Groundwater Application Review Summary Form

Application # G- 19376

GW Reviewer Steve Ahlquist/Travis Brown Date Review Completed: 2/15/2024

TO: Water Rights Section Date 2/15/2024
 FROM: Groundwater Section Steve Ahlquist / Travis Brown
 Reviewer's Name
 SUBJECT: Application G- 19376 Supersedes review of _____
 Date of Review(s) _____

Water-Level Measurements in Nearby Wells

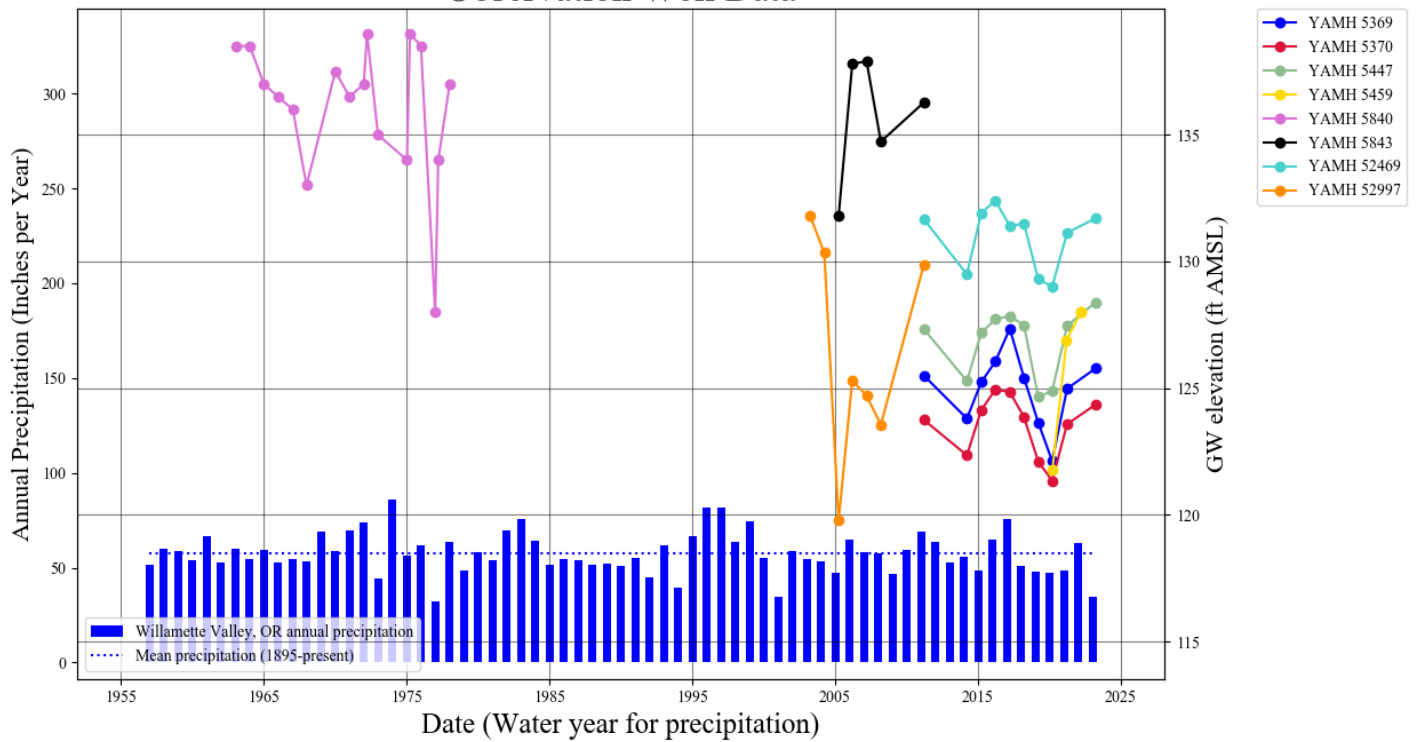
Long-term hydrographs in the area show no progressive long-term declines (see attached Water-Level Measurements in Nearby Wells).

This Time-Drawdown Worksheet

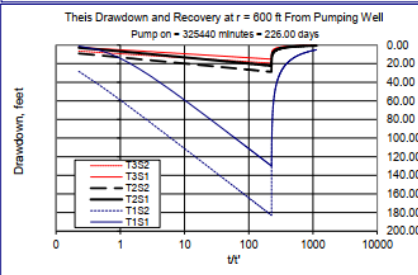
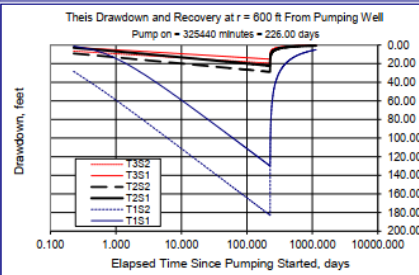
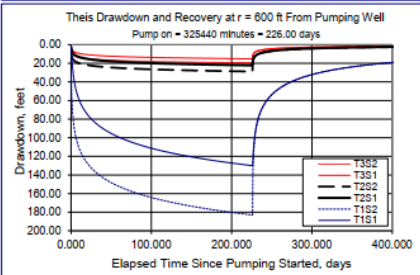
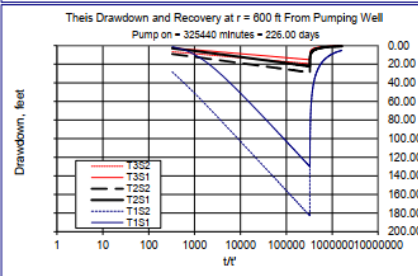
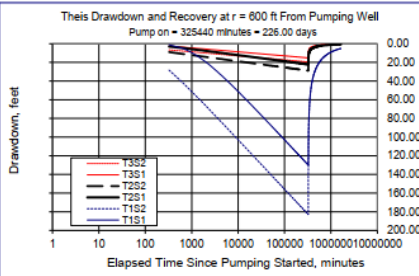
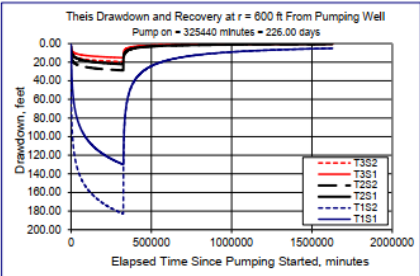
Several of the proposed POAs are less than ¼ -mile from known water wells. Theis (1935) drawdown analyses were conducted to assess potential well-to-well interference at nearby wells due to pumping at the proposed POAs. Permits issued for nearby POAs contain the standard condition requiring curtailment of pumping when interference with a neighboring well exceeds 25 feet of drawdown; any permit pursuant to this application would be conditioned similarly. Therefore, the potential for interference to nearby wells was evaluated based on the likelihood of well-to-well interference exceeding 25 feet due to pumping at the proposed POAs. Hydraulic parameters used in the Theis analyses are from pumping tests performed on nearby wells and from regional studies (Pumping Tests; Conlon et al., 2005). To be conservative, each proposed POA was evaluated individually, and it was assumed to be pumped continuously at the maximum requested rate (0.67 cfs/300 gpm) until reaching the requested annual volume of 300 acre-feet, which would take approximately 226 days. The nearest known well is YAMH 58088, located approximately 600 ft east-southeast of proposed Well 4. YAMH 58088 is an exempt domestic well completed to a depth of 138 feet bls and sealed to 37 feet bls. Results of the Theis analysis indicate drawdown at YAMH 58088 would likely exceed 25 feet after 59 days of pumping at Well 4. The next closest well, YAMH 54354, is located approximately 780 feet west of proposed Well 1. YAMH 54354 is an authorized POA under Permit G-11886 with a total depth of 218 feet bls. Results of the Theis analysis indicate drawdown at YAMH 54354 would likely exceed 25 feet after 100 days of pumping at Well 1. **Based on the anticipated interference at wells YAMH 58088 and YAMH 54354, groundwater for the proposed use will not likely be available within the capacity of the resource for the amount requested at proposed Well 1 and proposed Well 4. However, if the maximum requested rate were reduced to 0.56 cfs (251 gpm) or less in order to avoid the assumption of PSI (see Section C, below), then use likely would be within the capacity of the resource.**

To reduce interference with known wells in the area, the proposed use should be limited to the proposed locations for Well 2 and Well 3 or the requested rate should be reduced to 0.56 cfs or less.

Stream Depletion (Hunt) Model Analyses

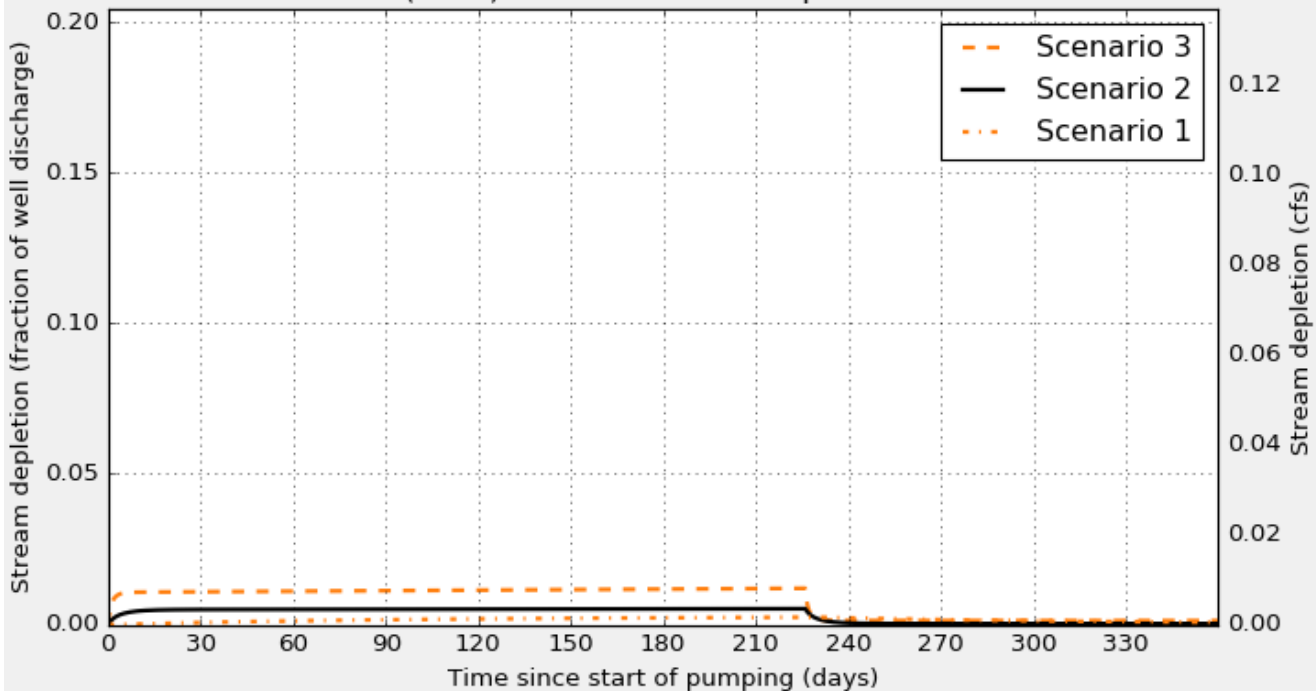
An analytical stream depletion model (Hunt, 2003) was used to estimate potential interference with streamflow due to the proposed use. Hydraulic parameters used in the model were obtained from regional data and studies (Pumping Test Reports, Conlon et al., 2005, Iverson, 2002). Specific parameter values used in the analyses are listed in the attached Stream Depletion Model Analyses. Potential interference estimates for SW1 (West Fork Palmer Creek) and SW2 (Palmer Creek) were modeled based on pumping of Well 4. Potential interference for SW#3 (unnamed tributary to the Yamhill River) was modeled based on pumping at Well 1. Other proposed well locations are farther from streams and are expected to result in less interference. Hunt model results indicate that stream depletion (interference) due to pumping of the proposed POAs is anticipated to be much less than 25% of the well discharge at 30 days of continuous pumping at the maximum requested rate of 0.67 cfs.

C6. **SW / GW Remarks and Conditions:** **PSI is assumed per OAR 690-009-0040(4)(c) because the requested rate of appropriation (0.67 cfs/300 gpm) is greater than 1% of the 80% exceedance flow. If the requested rate of appropriation is reduced to 0.56 cfs (251 gpm), PSI would no longer be assumed.**
